Board of Examiners of Water Well Construction
and Pump Installation Contractors

NOTICE OF GENERAL MEETING OF THE BOARD OF EXAMINERS
AGENDA

Date April 1, 2025

[Receipt 10034376](#)

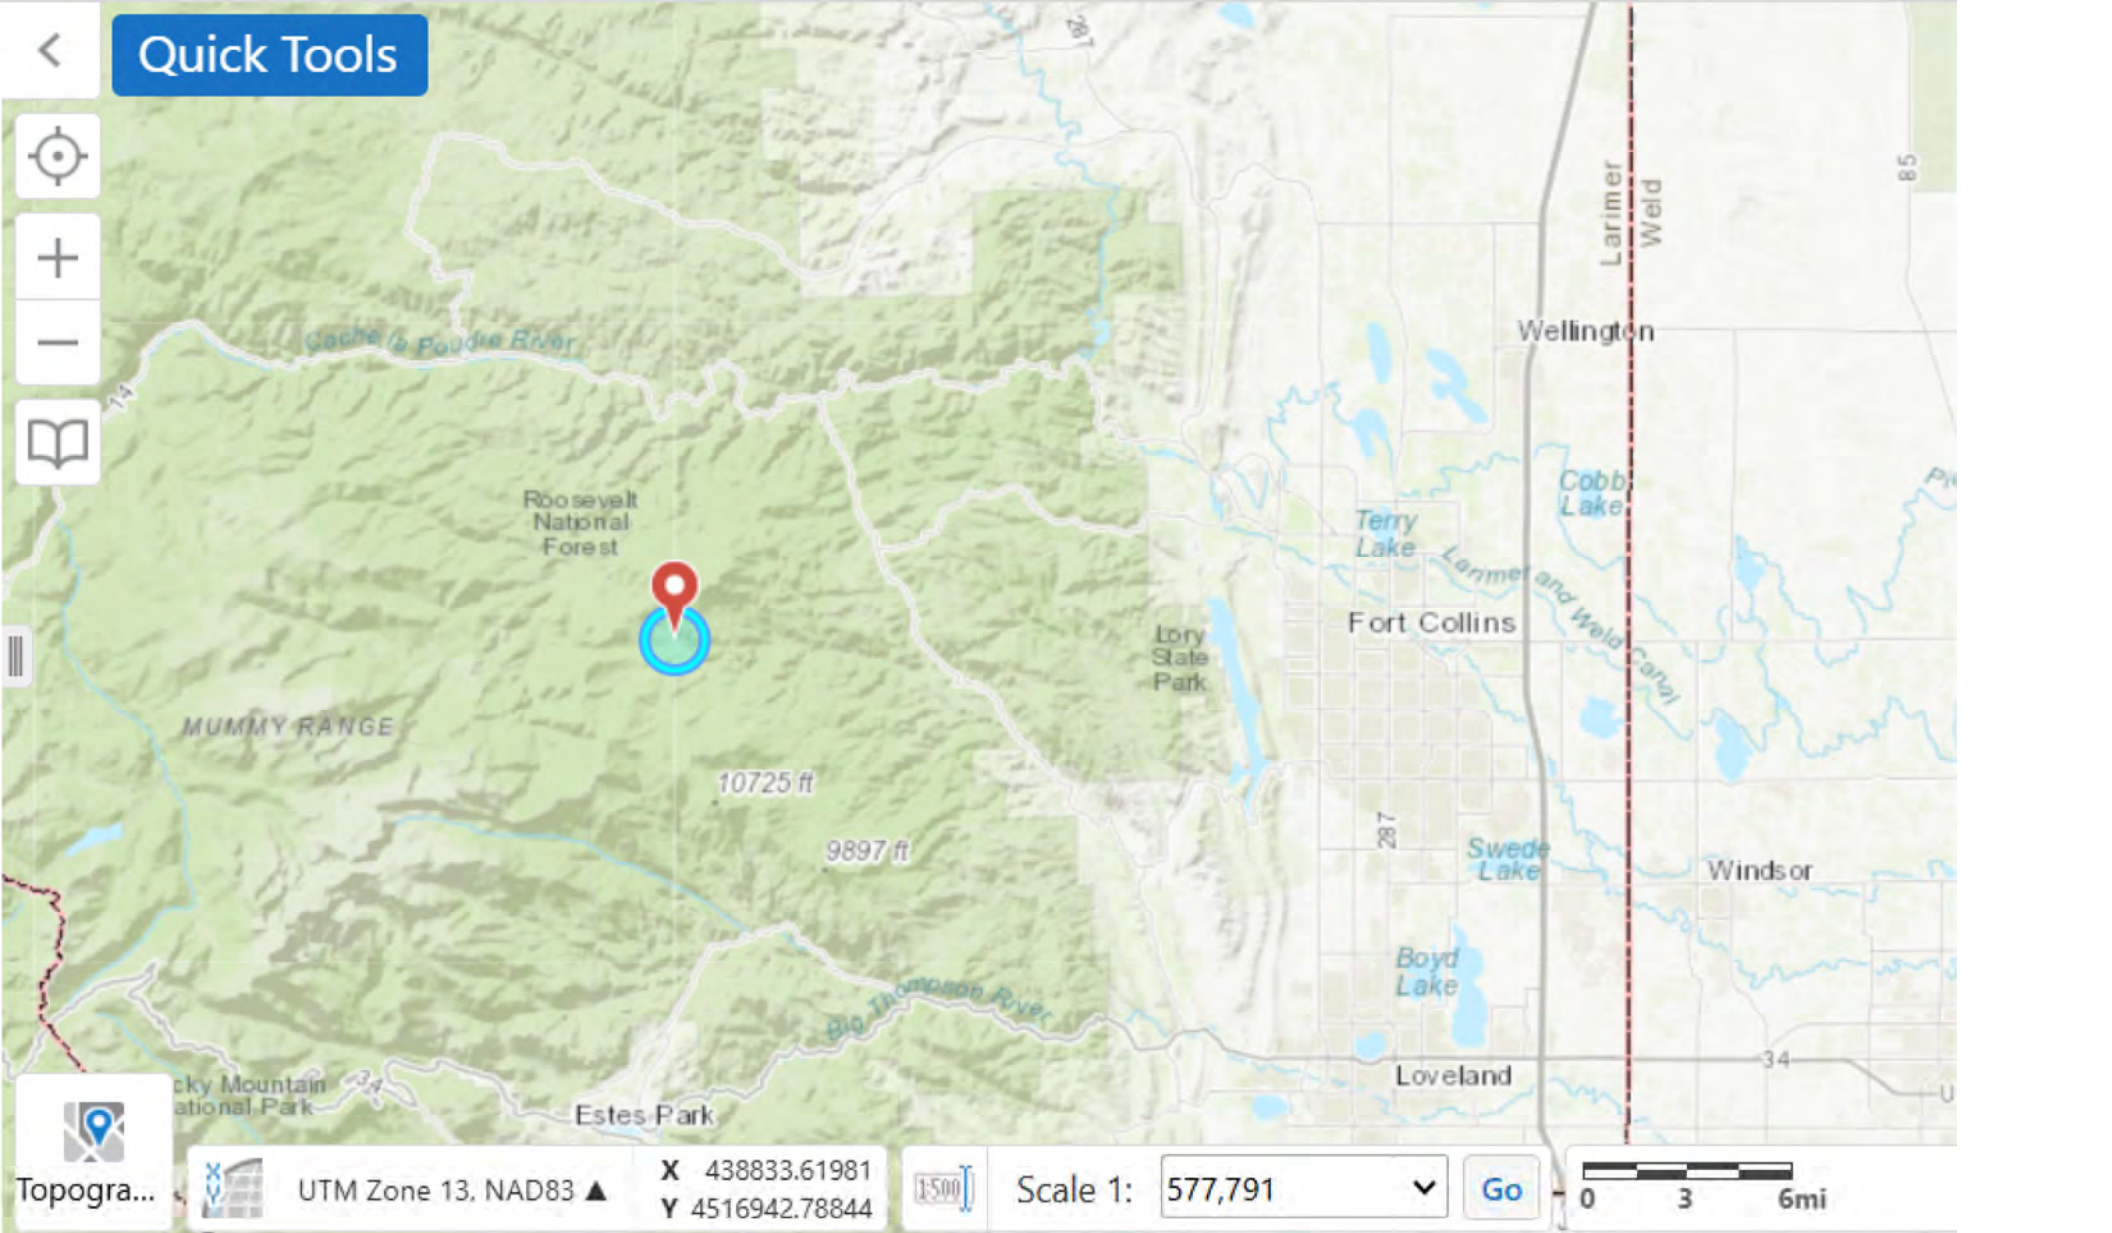
- Deficiencies Found by Staff Review
 - Annulus Rule 10.4.1 of the 1988 Rules
 - Casing Size 10.4.3 of the 1988 Rules
 - Sewerline Offset 10.2.2 of the 2016 Rules
- At February 2025 BOE meeting Board requested Forest Service Provide additional water quality test results (nitrates and nitrites)
- Forest Service to provide the Board with updates and results of the water quality tests.

Permit 254-WCB Receipt C620254 - Vicinity Map

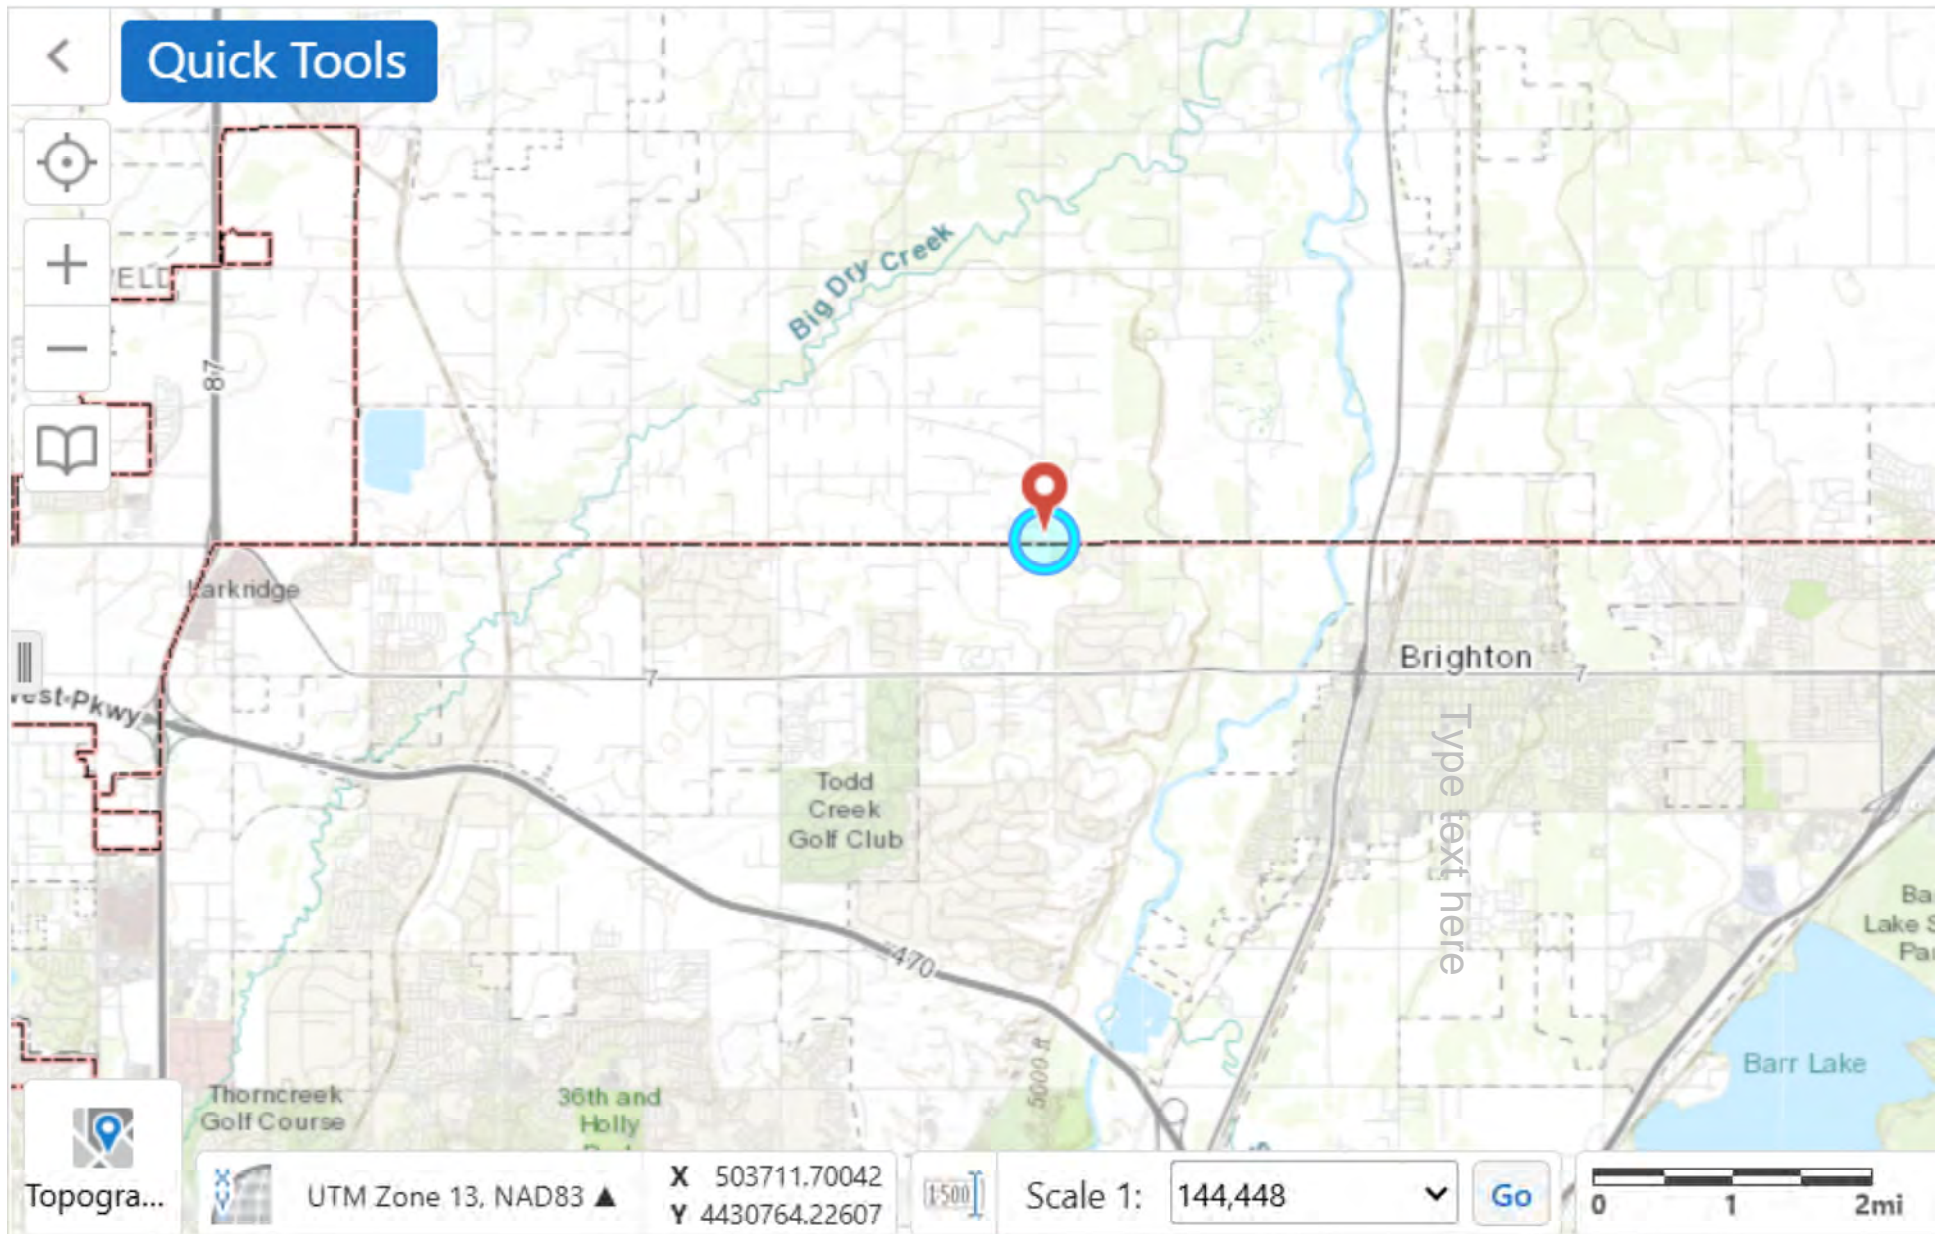
- Staff and contractor now question if Permit 254-WCB is for the subject well; Contractor indicates he picked the closest one and suggests the well might be unregistered.

- Board to consider request to appeal the denied variance for Permit 254-WCB, or consider same requested abandonment procedures for a possible unregistered well at this location.

- The methods of abandonment are insufficient to properly place grout inside and outside of the well casing, as required by Rule 16.2, or otherwise meet the intent of the rule.
- The proposed plan does not adequately demonstrate that the method of abandonment described in the variance request will protect the health and safety of the public and prevent contamination to Colorado's groundwater.

Permit 121346 - Vicinity Map

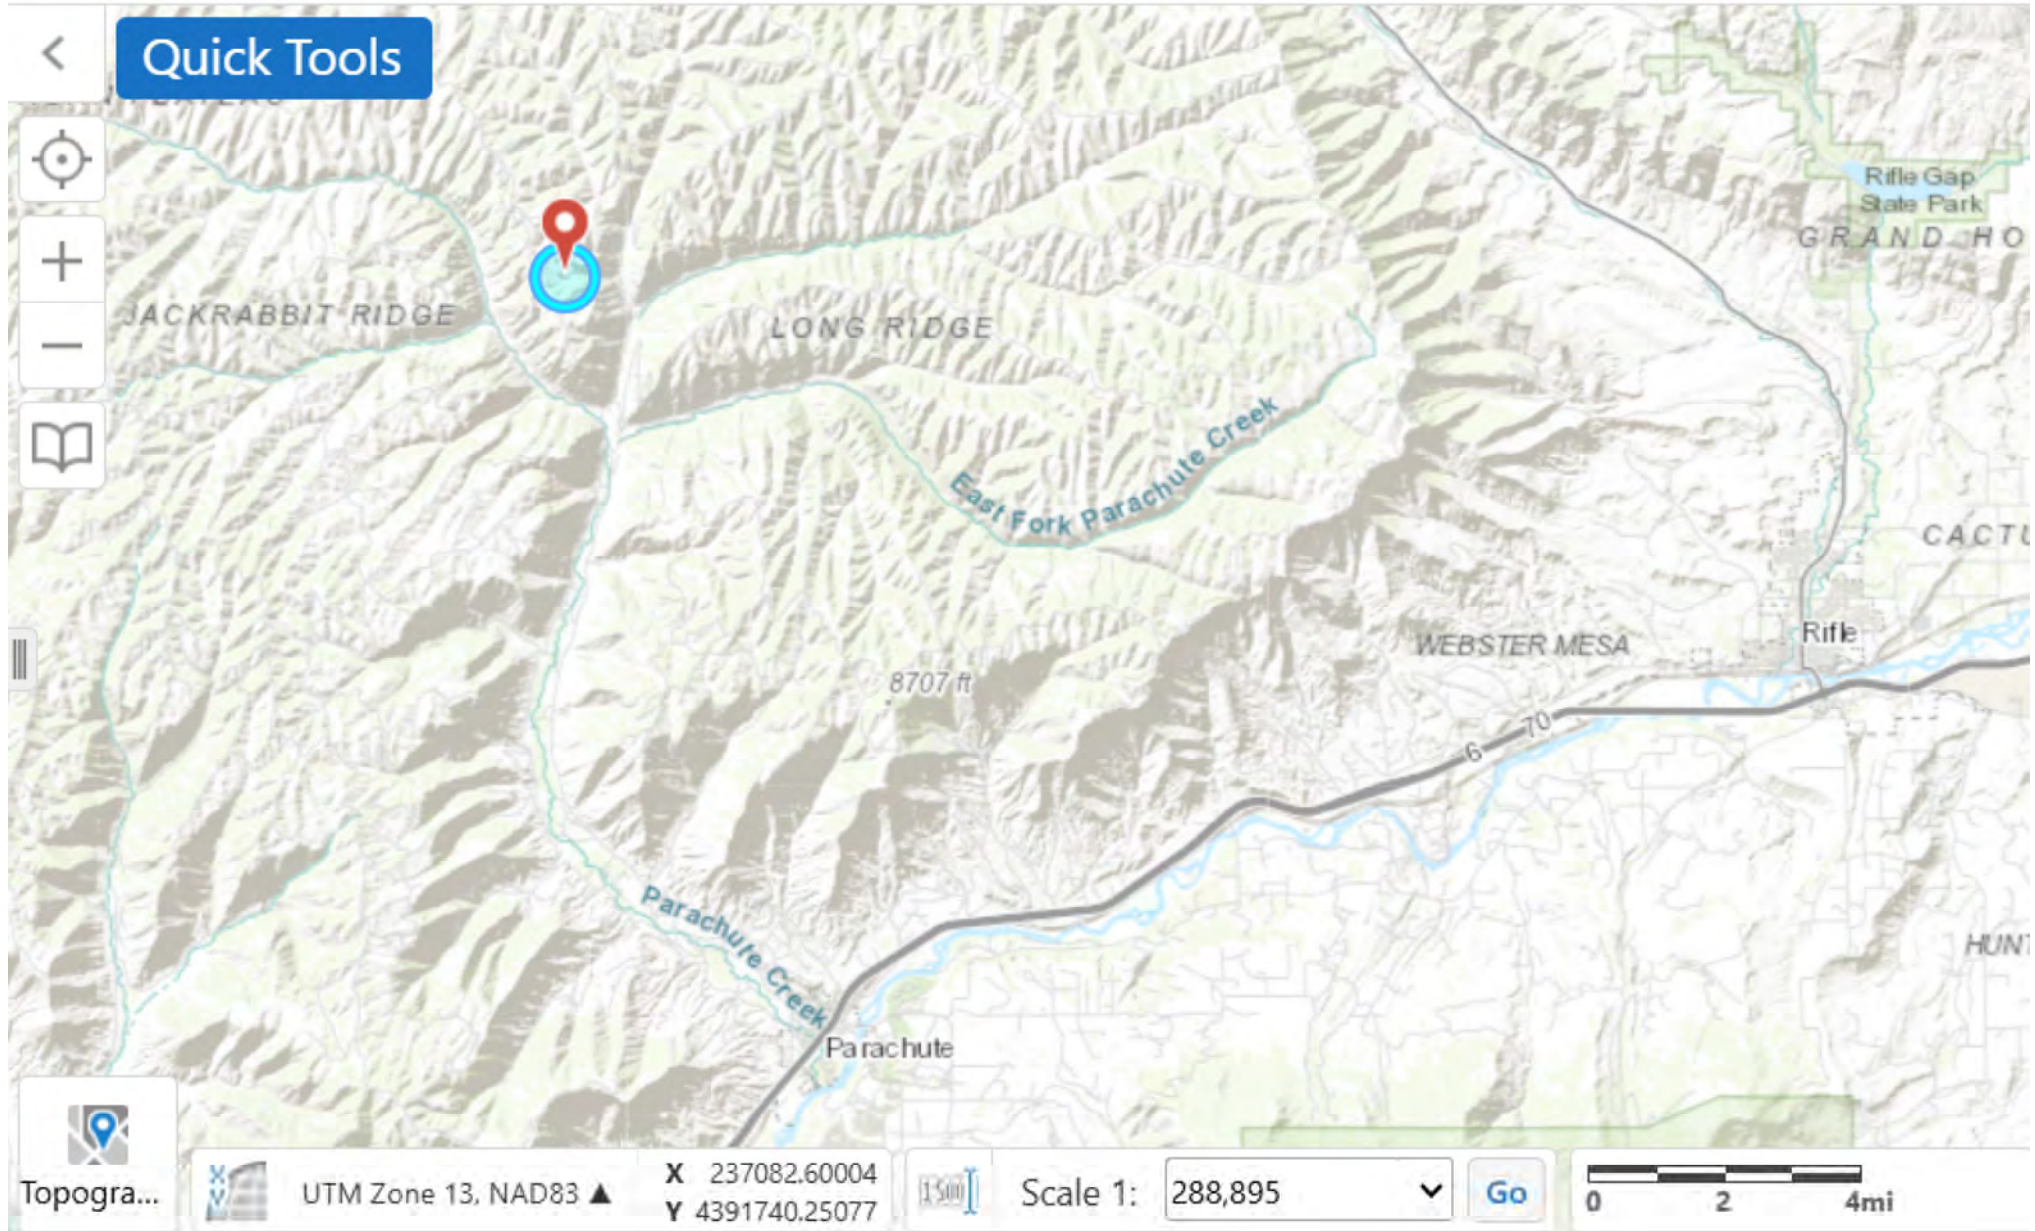
- The variance request opines on the owners intent based on the response “licensed” to question 4 of the permit application asking about the proposed “driller” as being in good faith. The intent of the owner to have the well constructed in accordance with the rules and regulations of the Board from his response to question 4 of the application is conjecture. The owner’s apparent neglect to follow the requirements of the Rules allowing only a contractor licensed by the Board to construct water wells or test holes at the time this well was constructed is a self inflicted hardship and is not a valid practical difficulty or unusual hardship in the Board Staff’s opinion.

Permit 121351 - Vicnity Map

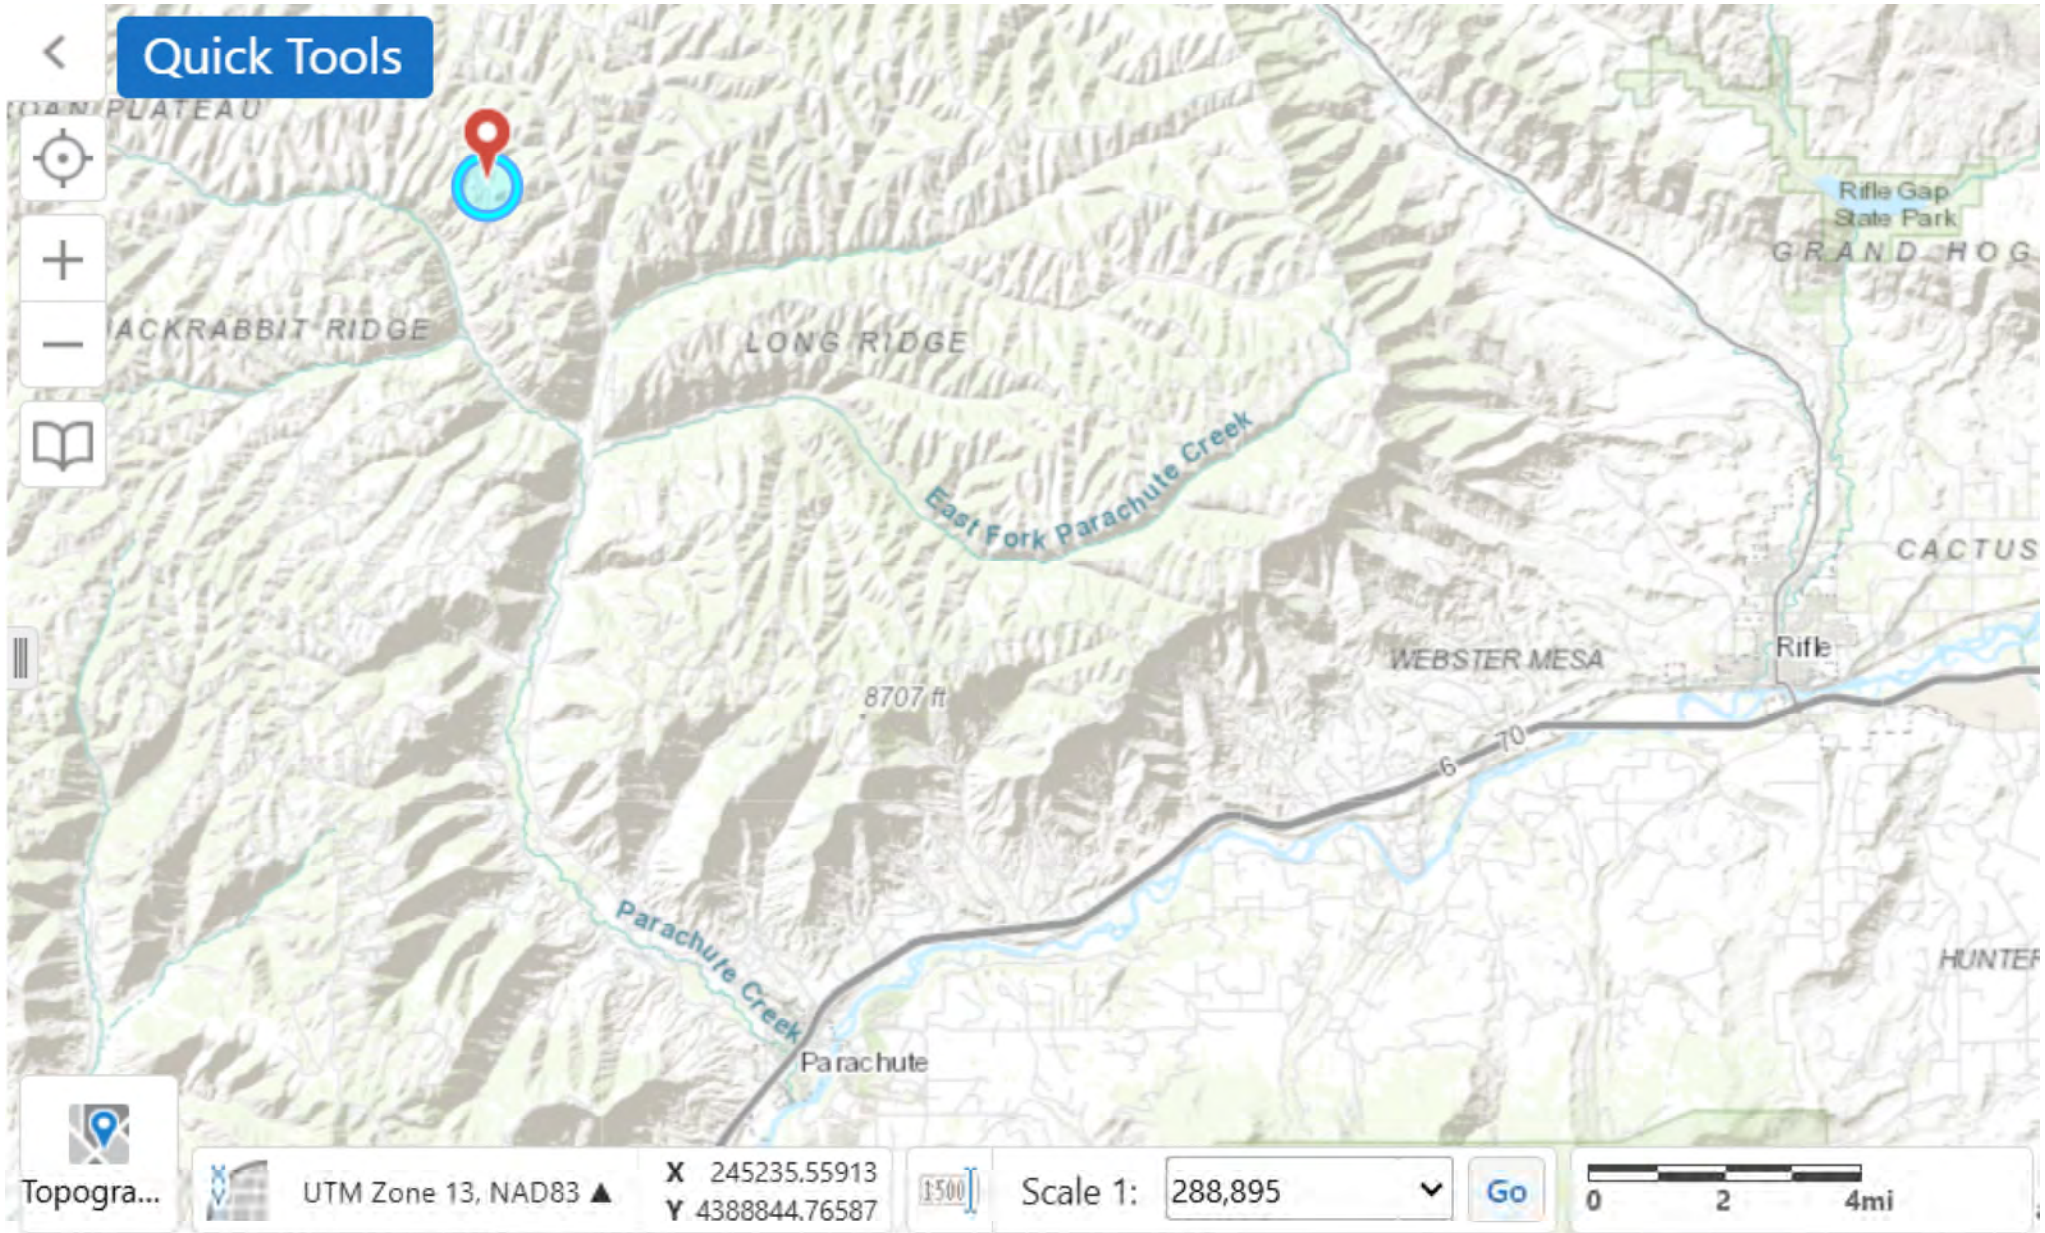
- The variance request opines on the owners intent based on the response “licensed” to question 4 of the permit application asking about the proposed “driller” as being in good faith. The intent of the owner to have the well constructed in accordance with the rules and regulations of the Board from his response to question 4 of the application is conjecture. The owner’s apparent neglect to follow the requirements of the Rules allowing only a contractor licensed by the Board to construct water wells or test holes at the time this well was constructed is a self inflicted hardship and is not a valid practical difficulty or unusual hardship in the Board Staff’s opinion.
